# National Committee on Uniform Traffic Control Devices

# National Committee on Uniform Traffic Control Devices (NCUTCD) Recommended Changes to Proposed Text for 11<sup>th</sup> Edition of the MUTCD Docket Number: FHWA-2020-0001

**NPA MUTCD Section Number:** Chapter 4F

Figure 4F-1. Typical Position and Arrangements of Shared Signal Faces for Permissive Only Mode Left Turns

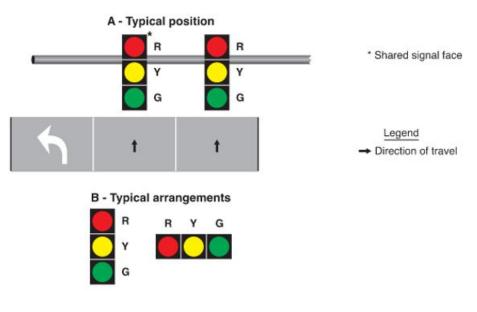
## **Figure 4F-1 Comments:** NCUTCD agrees with Figure 4F-1 as presented in the NPA.

Figure 4F-3. Typical Position and Arrangements of Separate Signal Faces with Flashing Red Arrow for Permissive Only Mode and Protected/Permissive Mode Left Turns

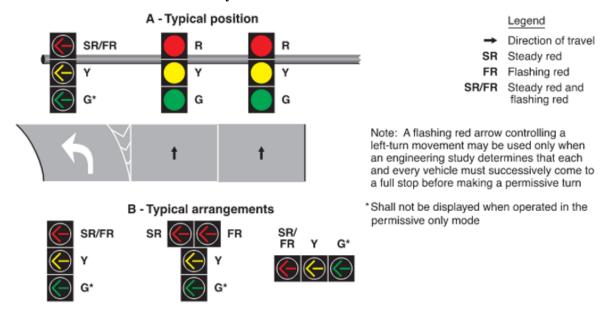
## **Figure 4F-3 Comments:** NCUTCD agrees with Figure 4F-3 as presented in the NPA.

Figure 4F-4. Typical Positions and Arrangements of Shared Signal Faces for Protected Only Mode Left Turns

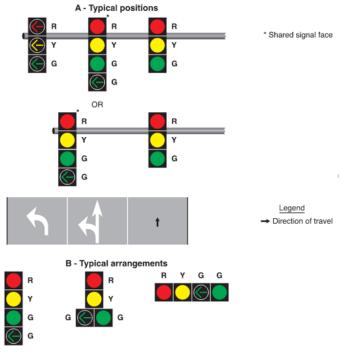
## **Figure 4F-4 Comments:** NCUTCD agrees with Figure 4F-4 as presented in the NPA.

Figure 4F-7. Typical Position and Arrangements of Separate Signal Faces with Flashing Yellow Arrow for Protected/Permissive Mode and Protected Only Mode Left Turns

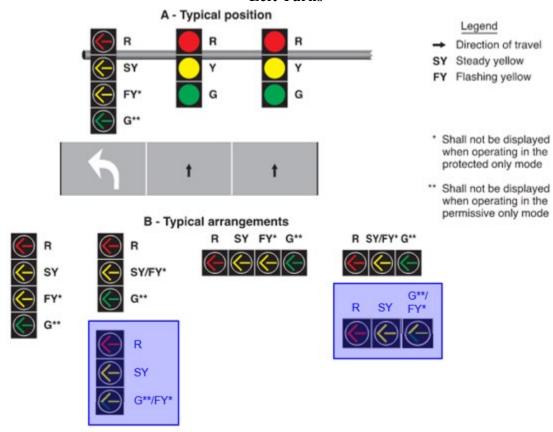
**Figure 4F-7 Comments:** NCUTCD recommends adding graphics to Figure 4F-7 illustrating displays for 3-section signal heads for flashing yellow arrow operation.

Figure 4F-11. Typical Positions and Arrangements of Shared Signal Faces for Protected **Only Mode Right Turns**

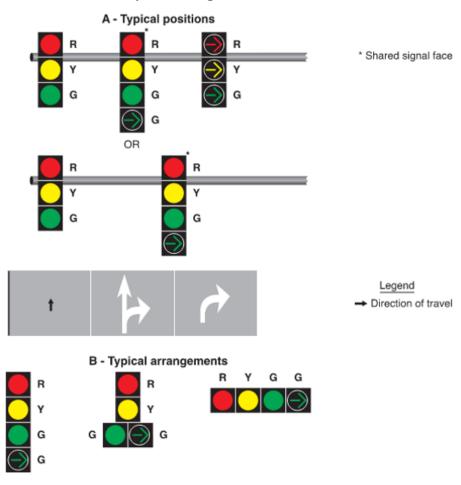
## **Figure 4F-11 Comments:** NCUTCD agrees with Figure 4F-11 as presented in the NPA.

Figure 4F-13. Typical Positions and Arrangements of Shared Signal Faces for Protected/Permissive Mode Right Turns

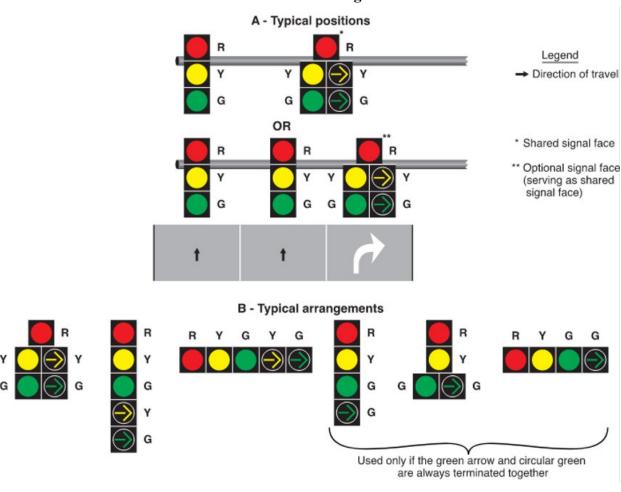
## Figure 4F-13 Comments: NCUTCD agrees with Figure 4F-13 as presented in the NPA.
